Village of Bayside  
9075 N Regent Road  
Architectural Review Committee Meeting  
May 10, 2021  
Remote Teleconferencing, 6:00pm

**ARCHITECTURAL REVIEW COMMITTEE  
AGENDA**

<p>PROJECT/SITE OWNER: Brett Bostrck</p> <p>PROJECT ADDRESS: 1440 E Fairy Chasm</p>	<p>PROJECT SUMMARY: New wood shed, 12' x 12' in rear yard. Shed finish materials will match existing house.</p>
---	---

<p><b>PROJECT/SITE OWNER:</b> Mitchell Ecker</p> <p><b>PROJECT ADDRESS:</b> 9508 N Sequoia Dr.</p>	<p><b>PROJECT SUMMARY:</b> New fence 280 feet 4-foot appears to be a black metal fence from photos provided</p>
--	---

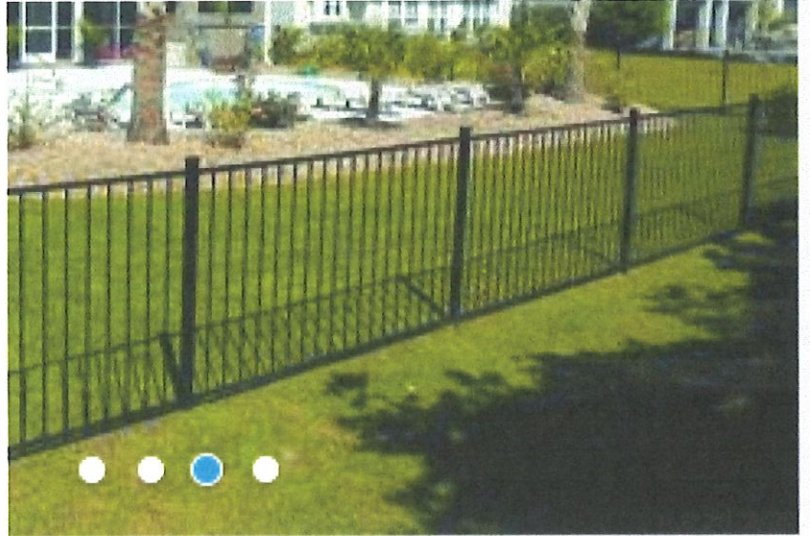
Proposed length 280' is approximately 30% of the total property perimeter length of approximately 923'.  
Per the code section copied below a 25% open fence is required.

**PROPOSED FENCE LENGTHS / TYPES COMPLY**

**PROPOSED HEIGHT IS COMPLIANT**

**Metal black finish**

Proposed Fence. will be 5 ft tall

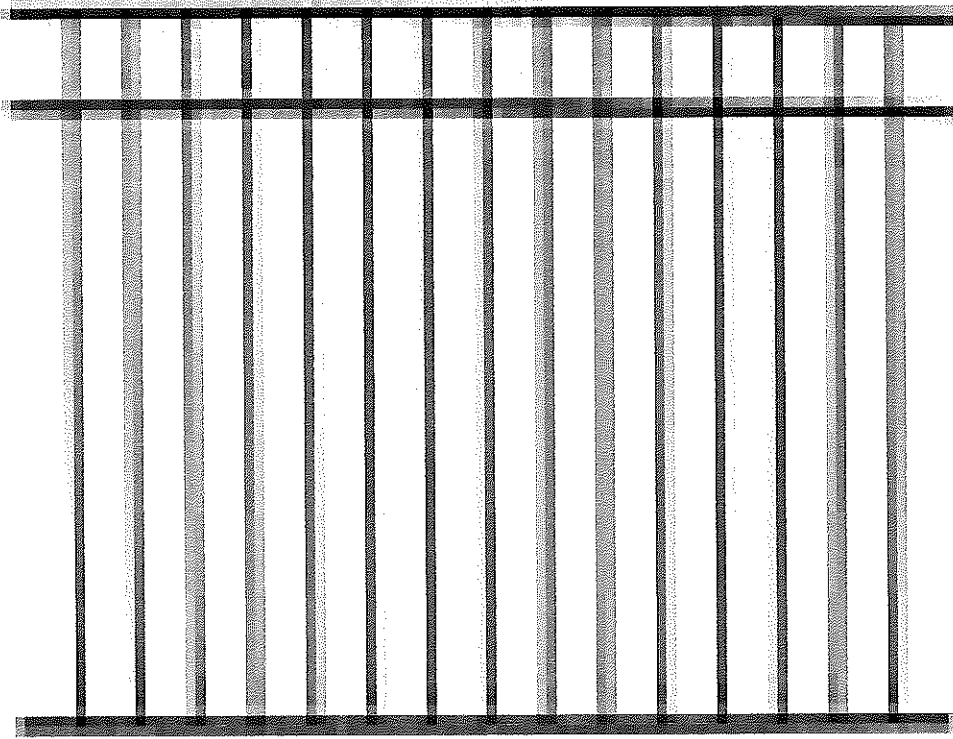
Proposed length unclear about 157' is approximately 9% of the total property perimeter length of approximately 1,882'. Per the code section copied below a 25% open fence is required.

#### **PROPOSED HEIGHT IS NON COMPLIANT**

Fences constructed within the front yard of a home shall not exceed three feet in height

**Black metal requires ARC approval.**

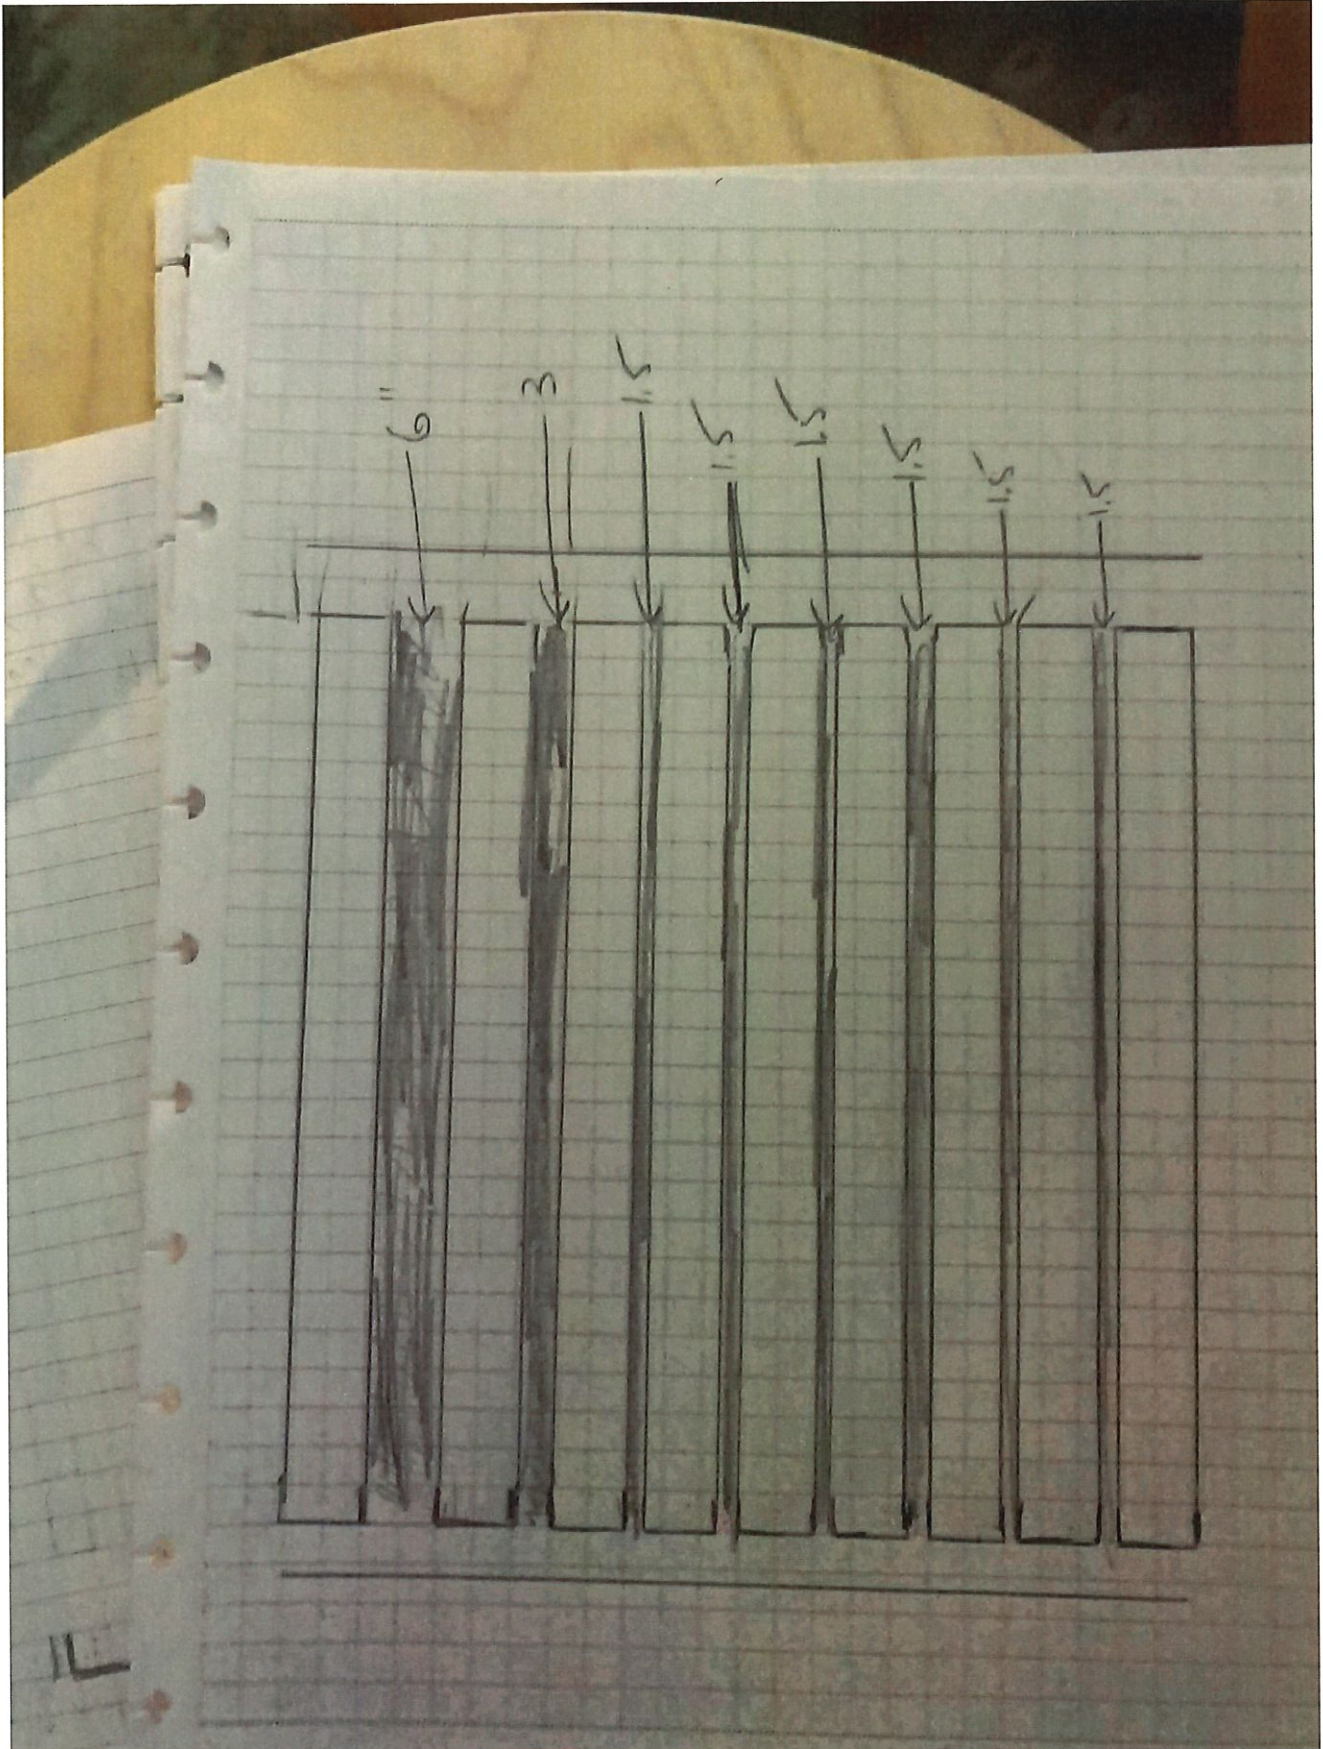
Proposed length unclear about 276' is approximately 46% of the total property perimeter length of approximately 600'. Per the code section copied below a 25% open fence is required, with the information provide, **I cannot determine if the proposed fence in compliant with the code section**

**PROPOSED HEIGHT IS COMPLIANT**
